# ROADWAY PLANS WYOMING ESTATES SUBDIVISION EL PASO COUNTY, CO

DESIGNED MAB	DRAWN HJG	CHECKED MAB	DATE 09/30/2020
ERLY ADP 3520 AUSTIN BLUFFS PKWY SUITE 102 COLORADO SPRINGS, CO 80918 PHONE (719) 266-5212	AMP	<p>Know what's below. Call before you dig.</p>	
PROJ NO. 03433 DWG NM. 03433-GrdgEros			
HOME RUN RESTORATIONS, INC 5090 WILEY RD PEYTON, CO 80831			
WYOMING ESTATES SUBDIVISION EL PASO COUNTY, CO			
ROADWAY COVER			
DRAWING NUMBER: SHEET 1

CULVERT PROFILES  
&  
ROADWAY DETAILS

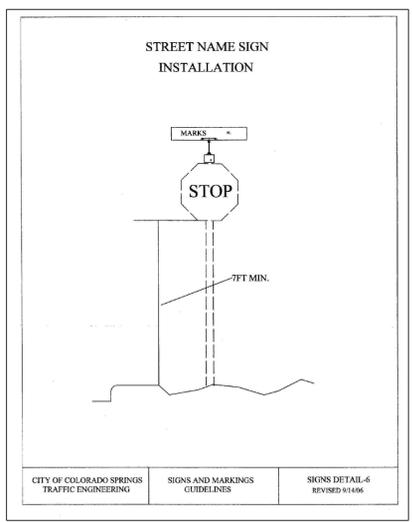
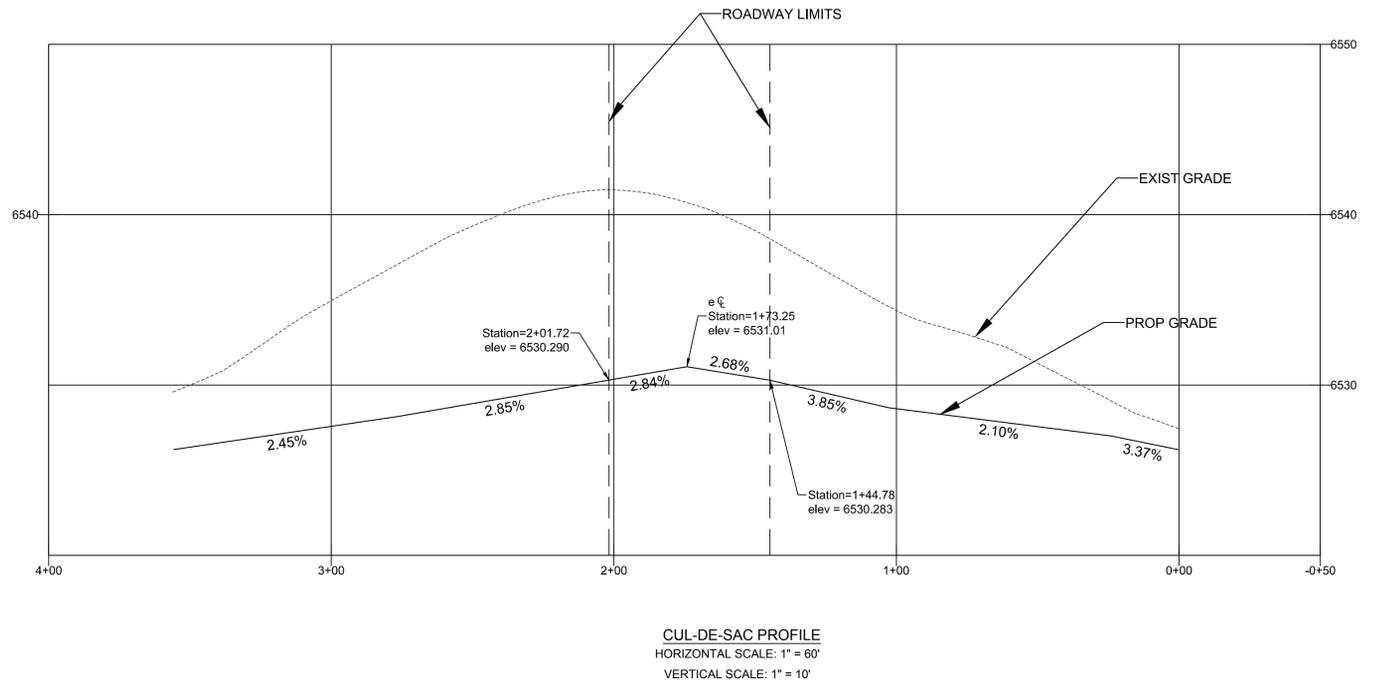
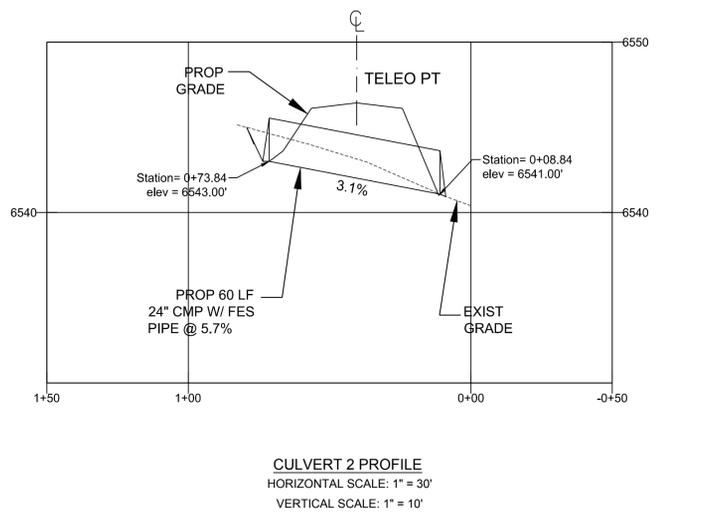
Review 1:  
Is this for bidding purposes? If so please indicate it with a footnote. Final pavement design shall be provided in a pavement report for review and approval by PCD.  
Review 2: Unresolved. Add a footnote that the indicated pavement section is an estimate or that it is for bidding purposes. A final pavement design shall be provided for review and approval prior to any paving.  
Review 3: Unresolved
